Addendum No. 6

PROJECT NO. 161026-00

PROJECT TITLE: Renovate Plant Science Building - Phase 2

DATE: **November 19, 2026**

1 MECHANICAL CHILLED WATER FLOW DIAGRAM - NORTH WING
NOT TO SCALE

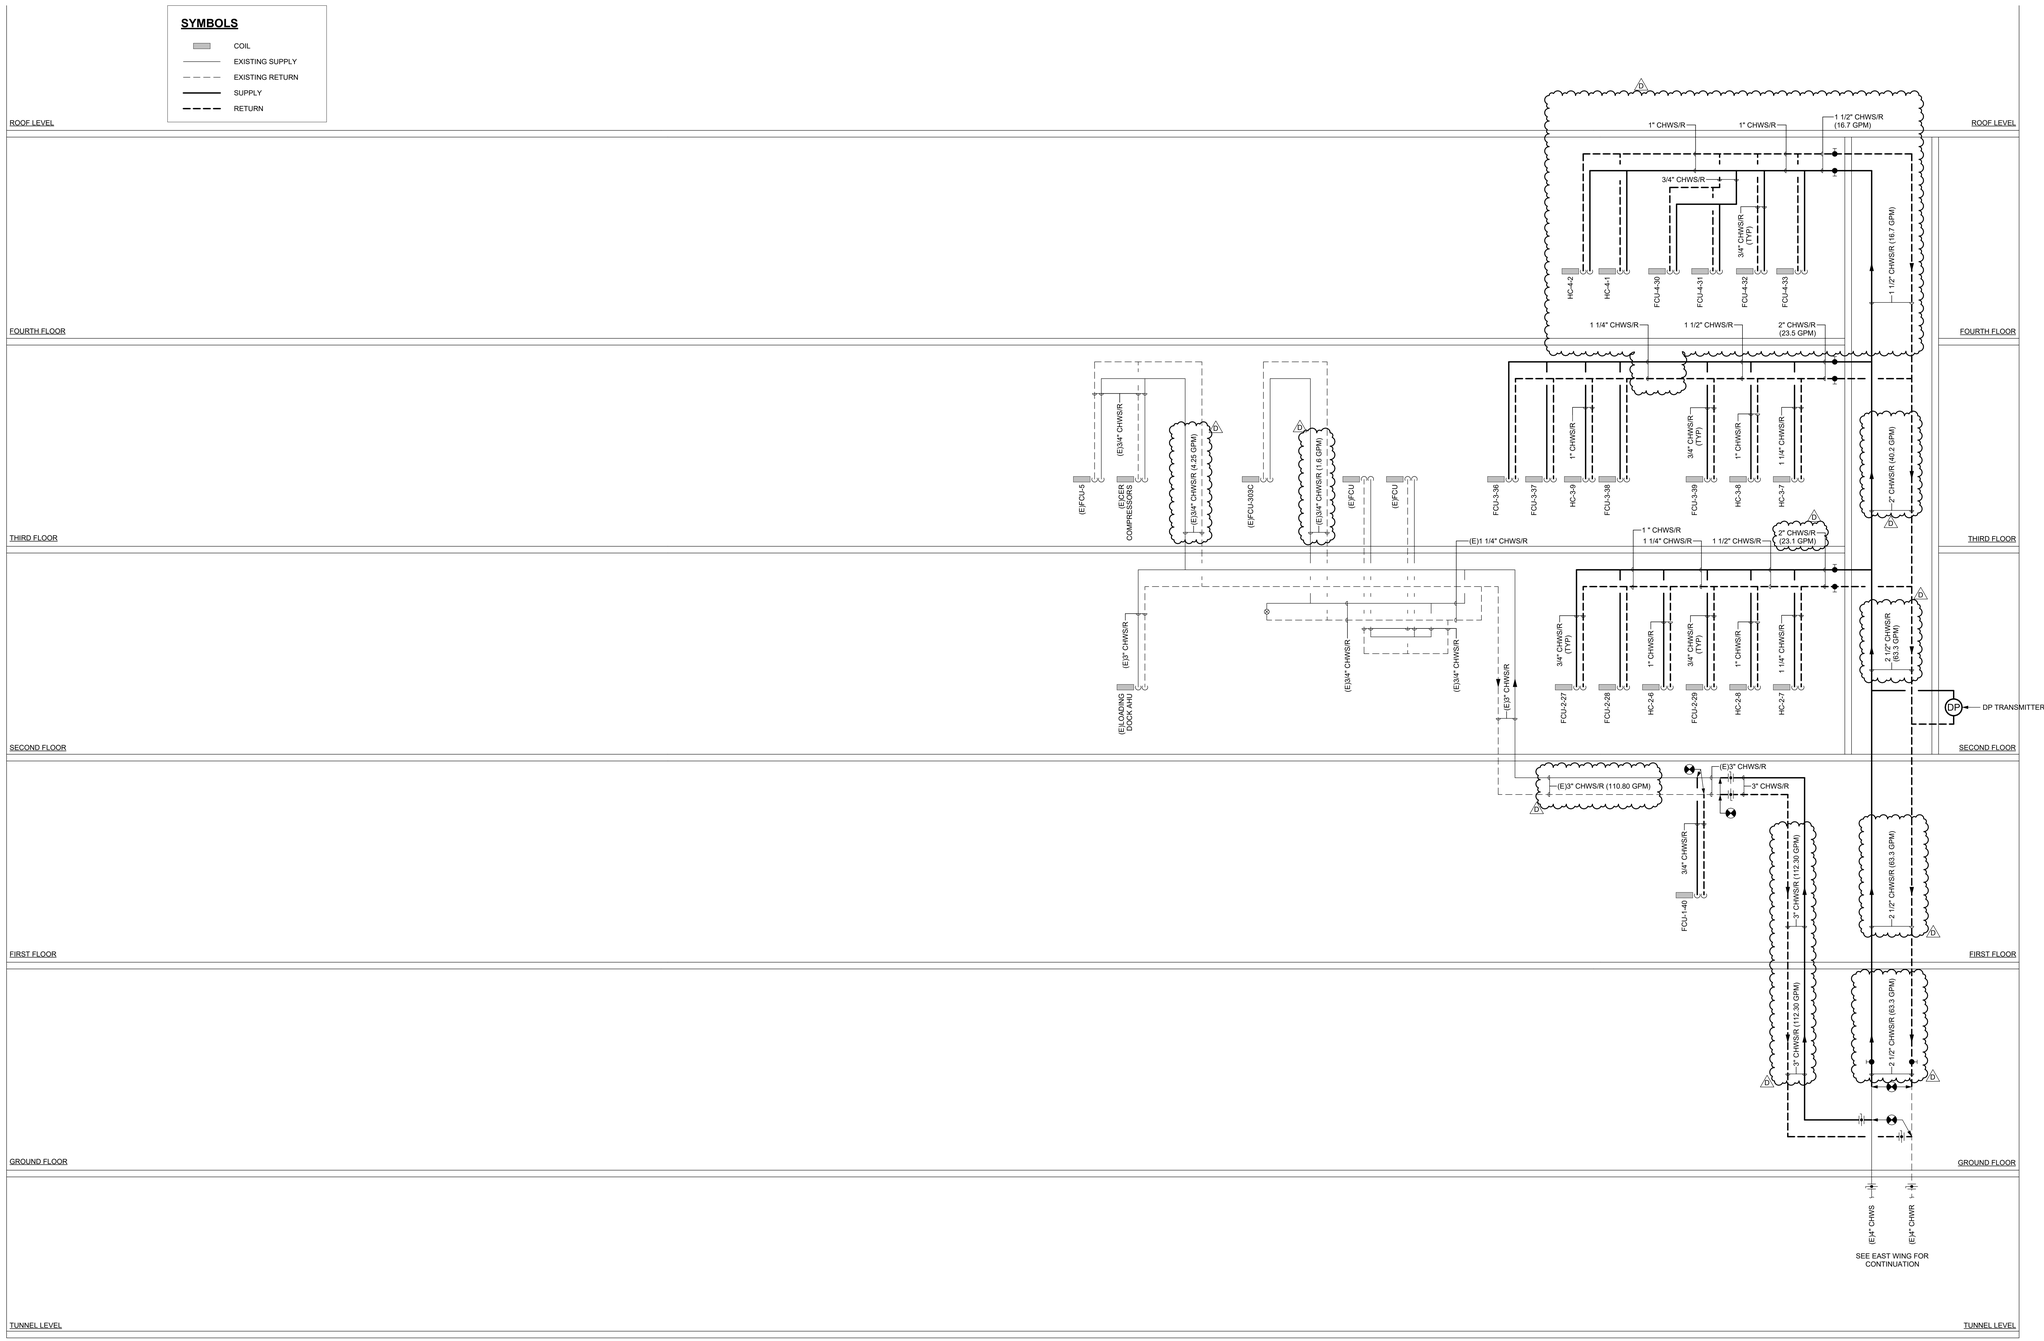
6.2bq: M6.7 – REVISED piping sizes, flow rates, configuration and equipment locations for CHWS/R system. ADDED flow rates for CHWS/R system.
6.2br: M7.2 – REVISED Detail 2 Ductwork Support Detail. ADDED Detail 7 Structural Framing Ductwork Support Detail.
